Re: Regeneron Ireland DAC Derogation Application for proposed refurbishment of outbuildings

We have been asked by our client Regeneron Ireland DAC Ireland to respond to your letter, issued on the 7th of May 2026. Our client is happy to address the concerns of the NPWS to improve the suitability of Building 12 as a dedicated bat roost and propose to amend the building design as detailed in this letter.

Figure 1. Aerial view (with dimensions) of layout for interior of building 12

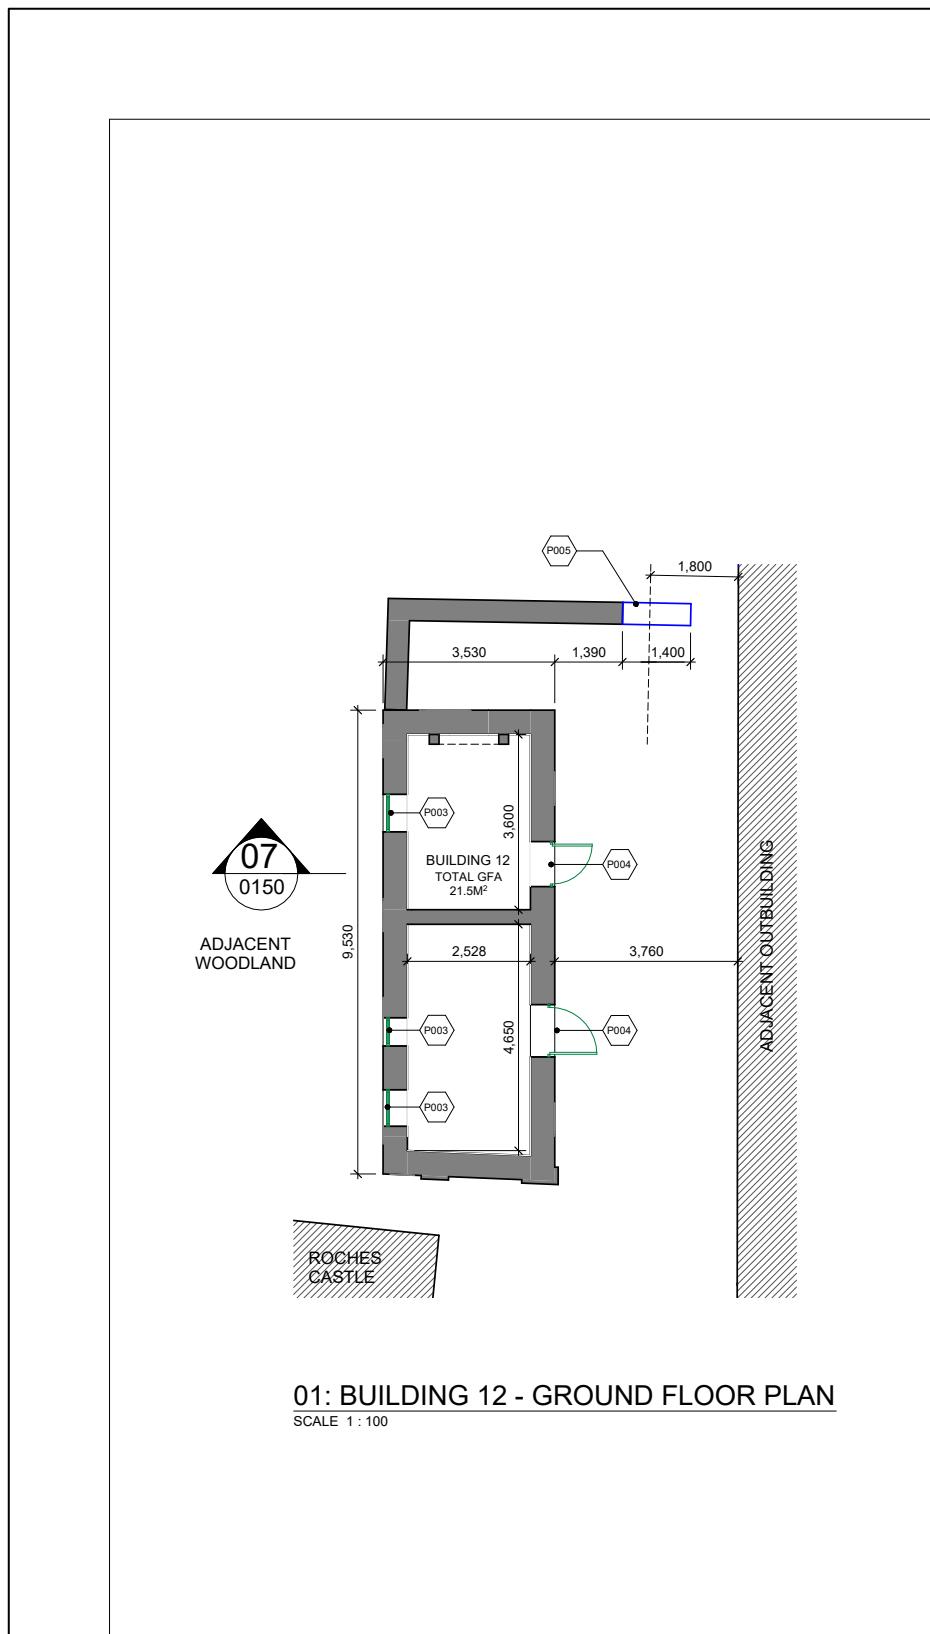
The provision of Building 12 as a bat house will potentially increase the roosting opportunities for a range of bat species. Currently, there are two rooms within building 12 as outlined in **Figure 1**. Room 1, the larger of the two rooms, will support a small bat loft (See Point 4). External entry points for bats, including Lesser Horseshoe Bats will be created via room 1. A 50 cm x 50 cm gap will be provided in the internal wall to allow bats entering room 1 to access room 2. This will be done by modifying an existing window (See plate 1).

Room 2 is a smaller room with an existing chimney and this room will be more effectively sealed to provide a darker, less draughty room suitable for Lesser Horseshoe bat (and other species). The chimney in this room will be capped and the existing door will be sealed. Lesser Horseshoe bats will enter this room from room 1 via a dedicated 50 x 50cm gap in the internal wall.

Figure 2. Existing building 12 cross-sectional dimensions

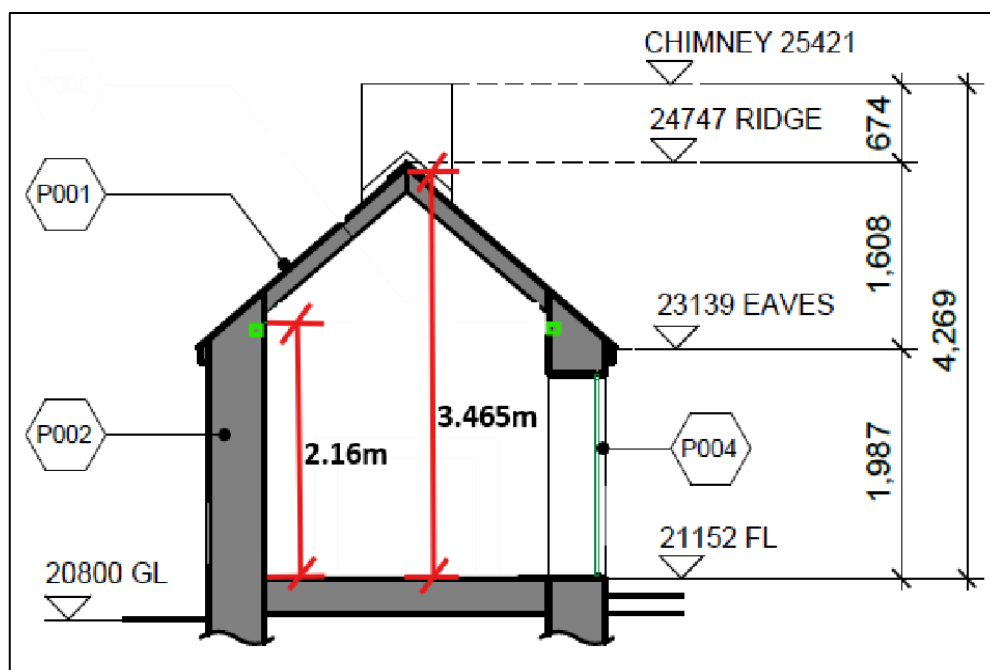
NPWS letter notes: *There are some vague terms used in relation to dimensions of the proposed bat loft. Terms such as “ideally” and “preferably exceed 2.5m....” are used. Clarity and commitment is required on what exactly the dimensions will be and that they will be suitable for the proposed purpose.*

Therefore we have modified the overall design to include a reduced loft space (in room 1). The loft space will have internal dimensions of 1.6 m (height) × 2.52 m (width) × 2.0 m (length) (See Figure 2). A hotbox for Lesser Horseshoe bat in room 2 as outline in the Point 5 response.

Figure 3. Triangular plywood panels fixed to the rafters trap warm air

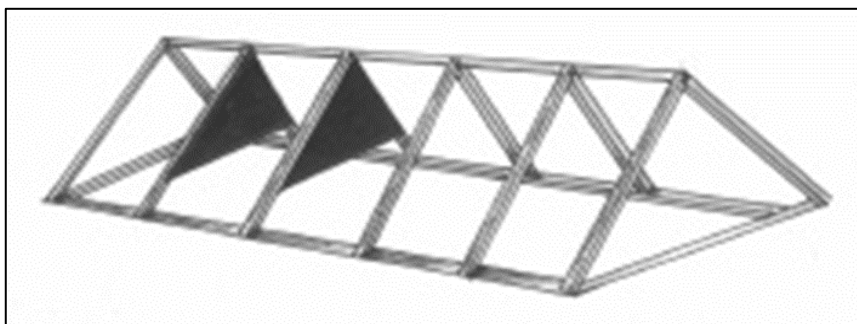
NPWS letter notes: *Provision for Lesser Horseshoe bats: We recommend providing potential access for Lesser hoe Bats. These will require a specific larger opening that bats can fly through (this will also be suitable for Brown Long-eared bats), as Lesser Horseshoe bats have been recorded in the area. To provide additional roosting space for them a 'hot box' should be installed in the apex of the roof of Building 12, following specifications in the Vincent Wildlife Trust Lesser Horseshoe Bat Conservation Handbook along with a predator proof access point for them.*

Given that room 2 is relatively small and will be well-sealed, a hotbox with a base may overheat. Therefore, using a series of baffles is considered preferable as it provides a range of temperature regimes which may also benefit other bat species.

It is therefore proposed that plywood panels will be installed between the rafters as shown below to make small areas of enclosed roosts. The panels are cut carefully to make an air-tight seal with rafters. It is recommended to use 18mm plywood to provide better thermal mass. The plywood will drop vertically for 700mm (from apex to base).

Plate 9. Large cankers in some trees provide potential roosting site for bats.

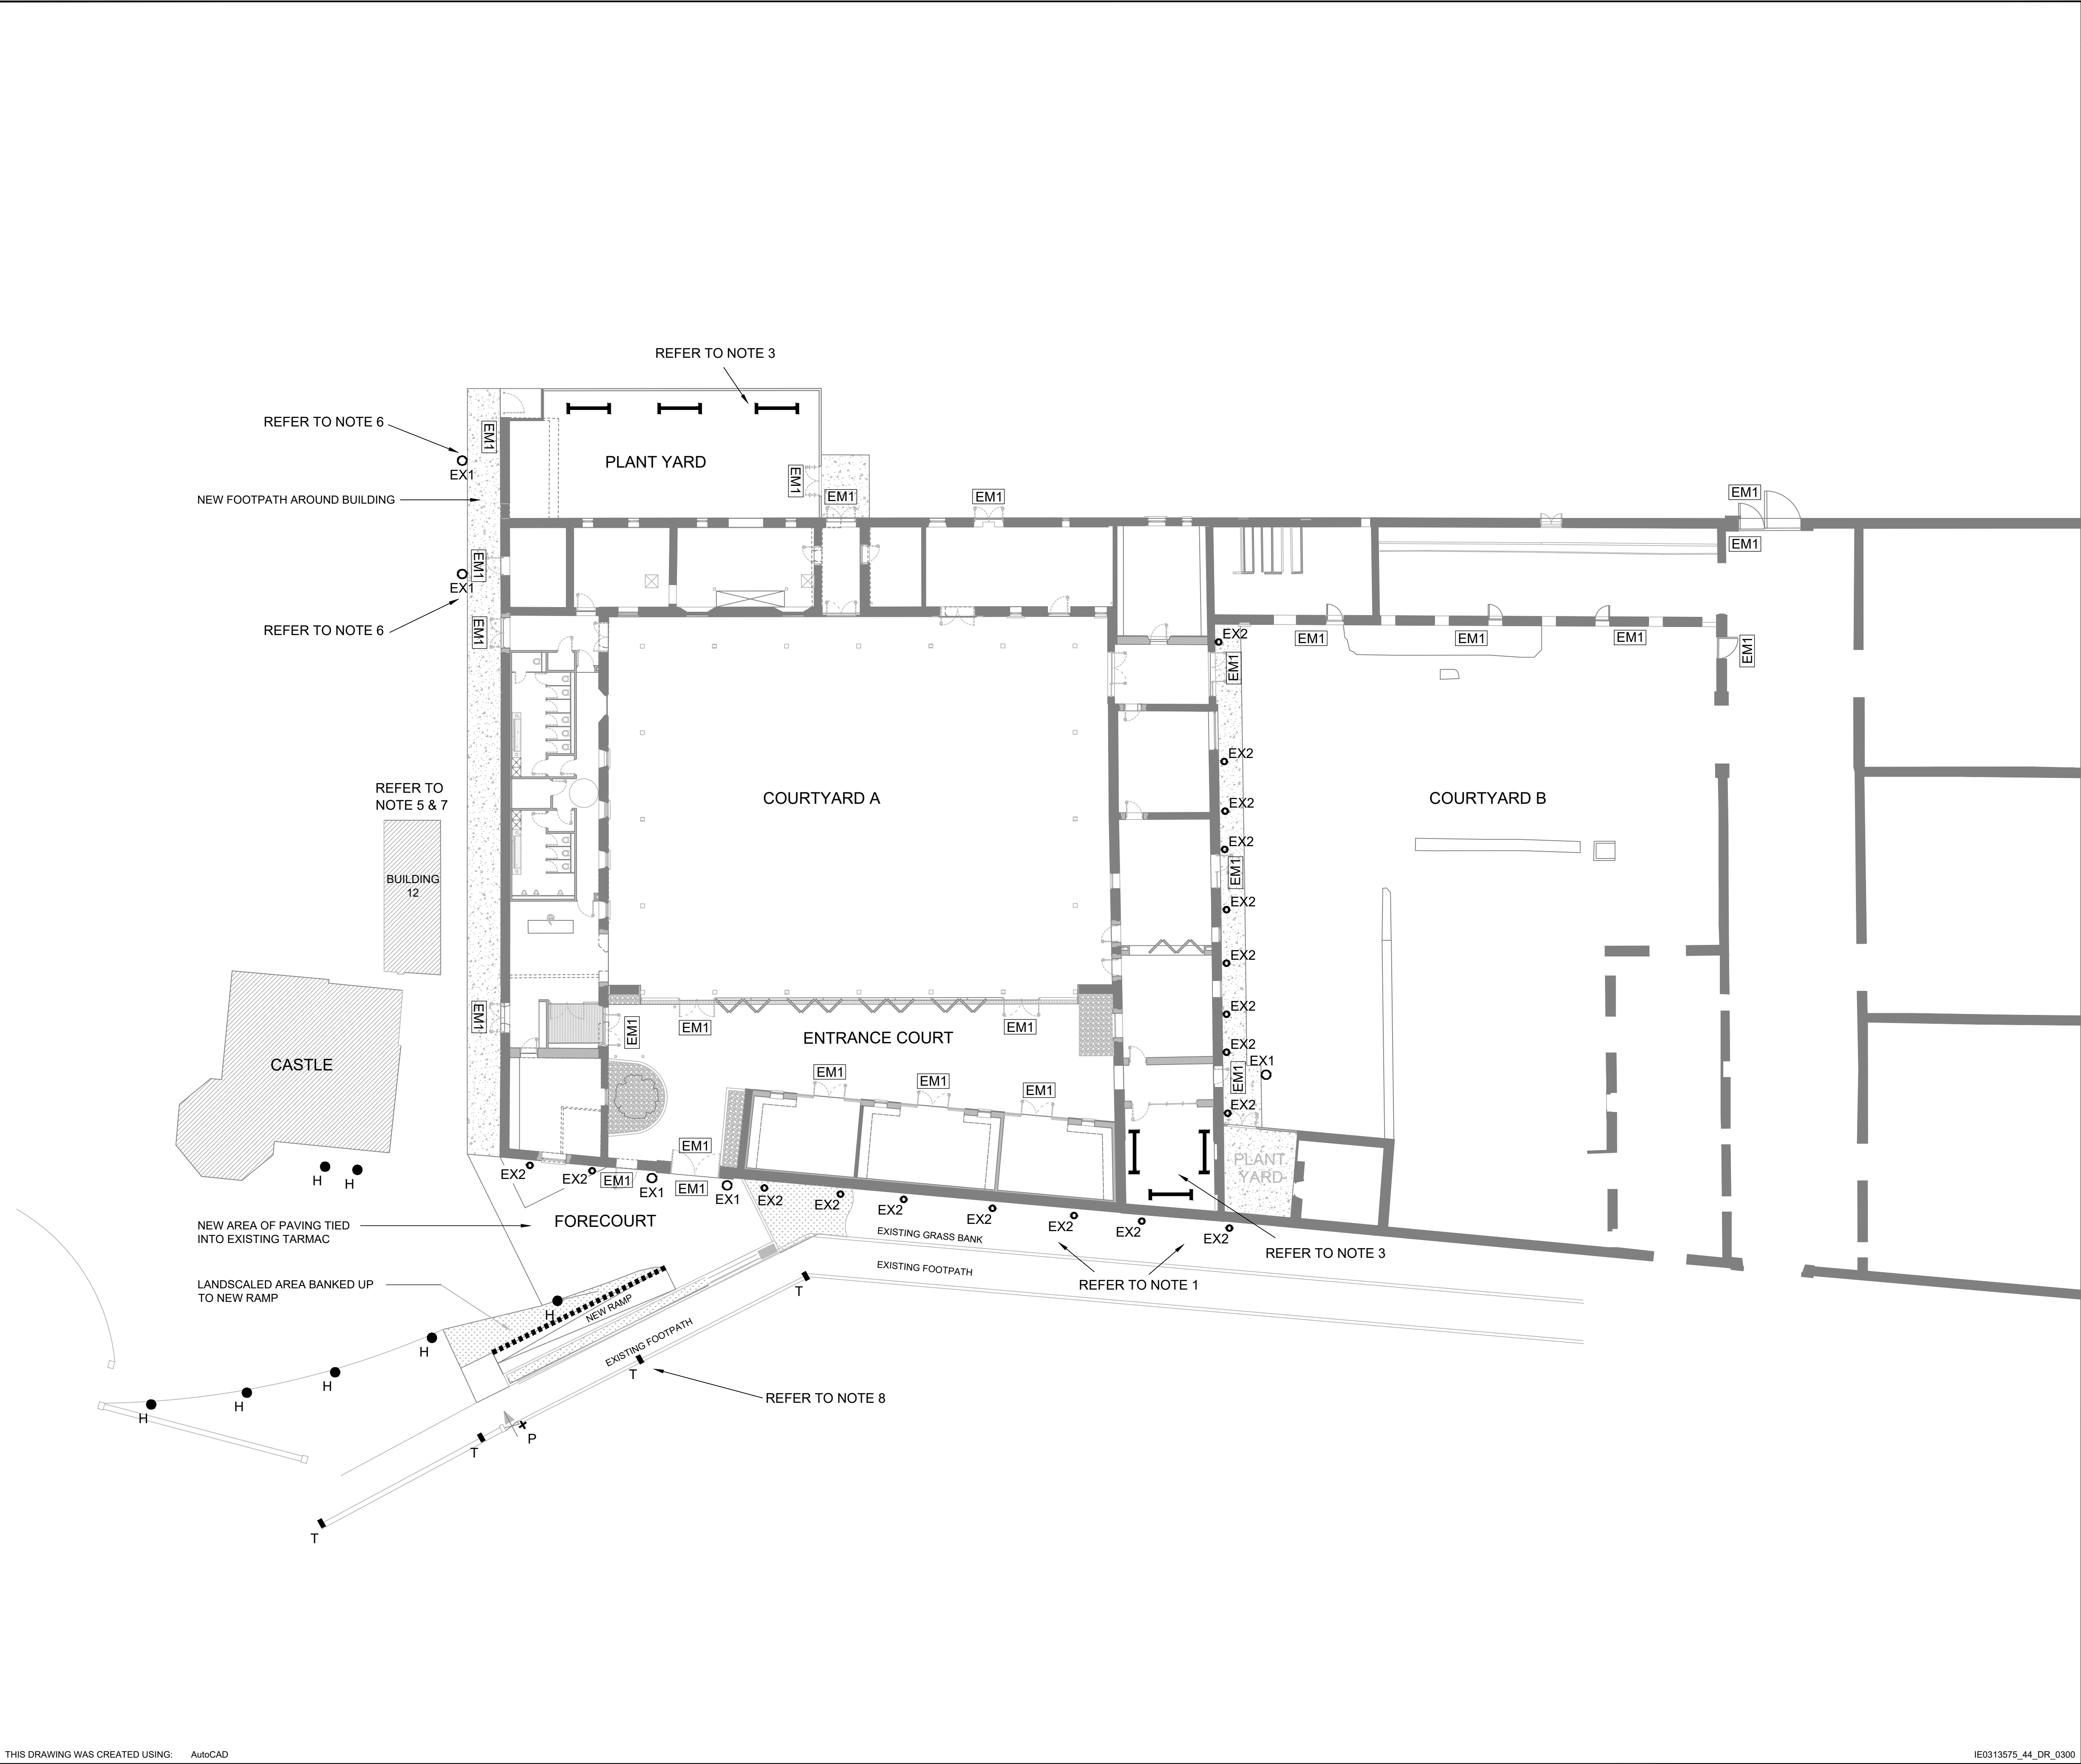
NPWS Notes: *External management and future use of adjacent parkland/scrub/woodland to maximise potential for foraging and commuting bats. There is no mention in the report and proposed mitigation of tree and vegetation management around the proposed bat house. This is an essential component and requires clarification.*

Response: Regeneron Ireland DAC have confirmed that no major works are proposed to remove any of the existing trees or to build any new structures. The existing woodland area is managed as a recreational area for employees and there is a heavy emphasis on biodiversity management. There is a diverse mixture of tree species and older trees have not been removed but have been cut back and stumps retained. Some of the more mature trees have existing cracks, crevices and cankers which could potentially be used by roosting bats. Management within the existing woodland is not intensive and their areas of dense grasslands with low levels of lighting. Bat boxes have been positioned on some of the mature trees to provide potential roosting habitat.

As an enhancement measure it is proposed that an additional 10 Oak and an understory of 20 Hawthorne will be provided within the woodland area. Any changes in management including tree removal additional lighting change in recreational usage patterns changing mowing regime etc will only be implemented if assessed by the supervising ecologist and who and if there will be no significant impact on local ecology.

Woodland & Bat Habitat

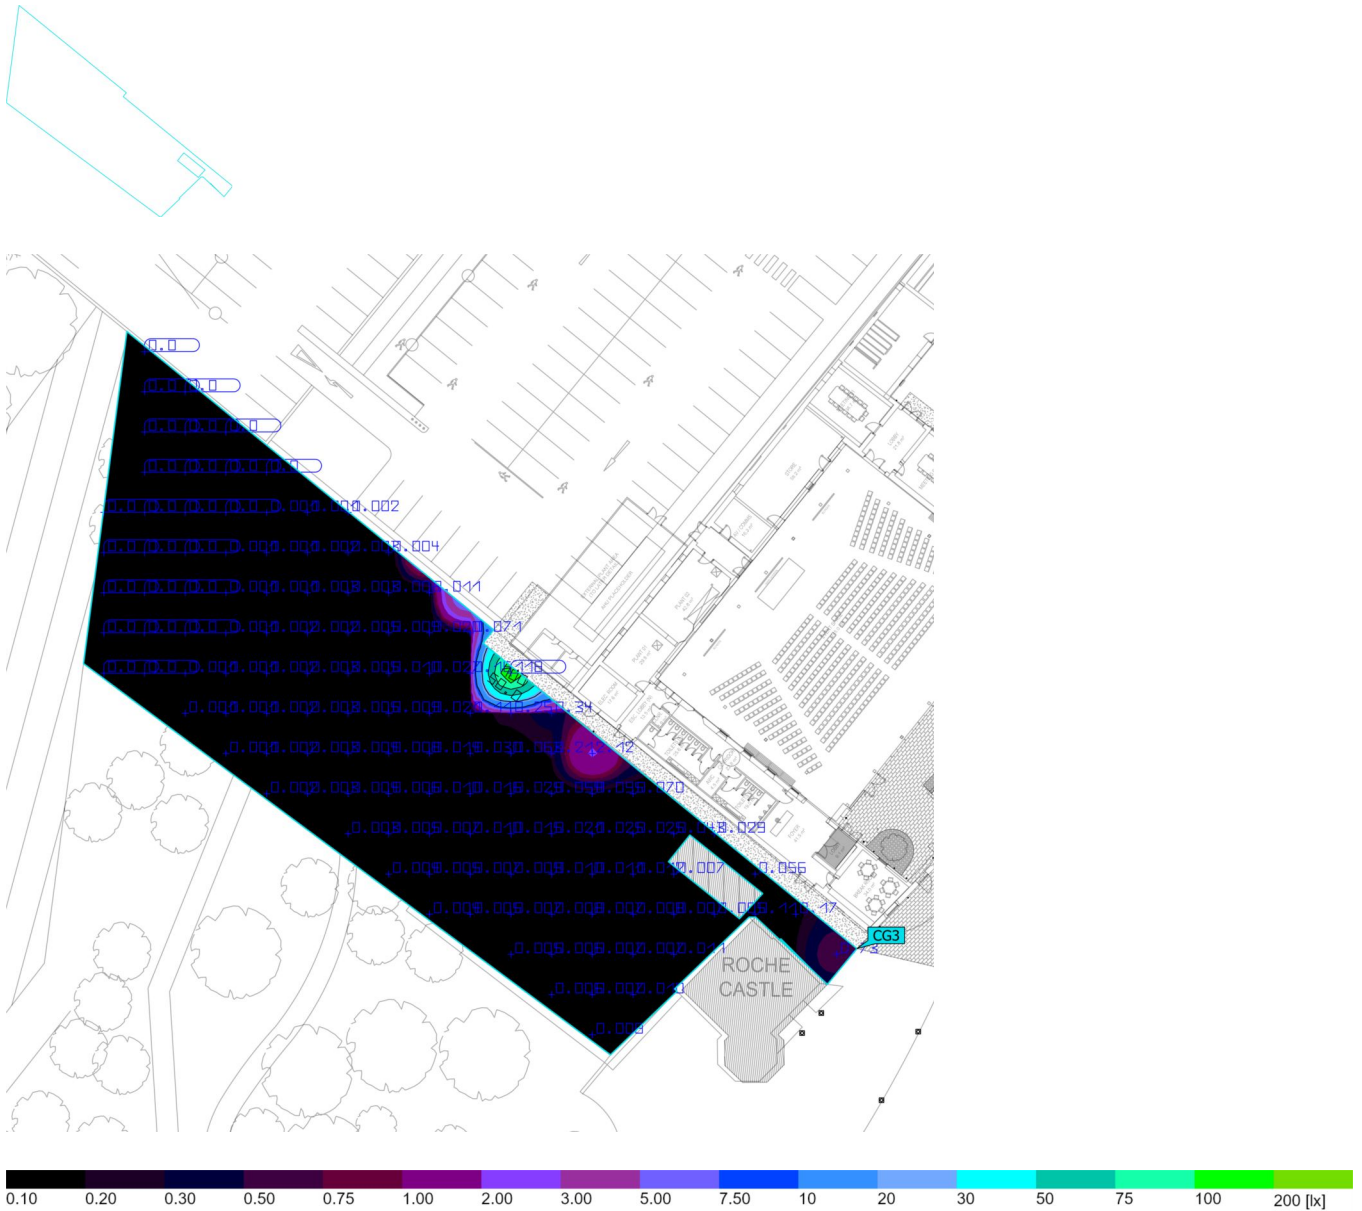
NPWS notes: There will be no point in establishing compensatory bat roost if external conditions are unsuitable for bats. Some vague and unquantified commitments have been made in this regard. In relation to lighting, the following is stated: "The building is located within a relatively dark part of the site complex adjoining parkland. Lighting in proximity to the proposed bat house has been minimised and access points for bats will be located so as to minimise light spillage on bat entry/exit points" "where possible" is used in relation to LED directional lighting. These are vague terms with no firm measurable commitment or outcome. NPWS require exact details of what will be done to minimise lighting and light spillage around the roost and on adjoining habitat. Specifically, what will be the measured lux values around the roost and on adjacent foraging habitat and will those levels be below the recommended levels for the species concerned? Is the adjoining Roche Castle going to be illuminated at night, is the perimeter of the site illuminated at night, will adjoining buildings be illuminated, if so, what changes are proposed? If proposed light levels are too high, the proposed bat roost may be obsolete.

Response: Detailed lighting plan and light contour drawing has been provided by PM Group. There is no lighting proposed around the roost location and lux levels here will be below 0.00 lux, ensuring that light spillage will not prevent usage of this roost. Please see Appendix 1 for full details.
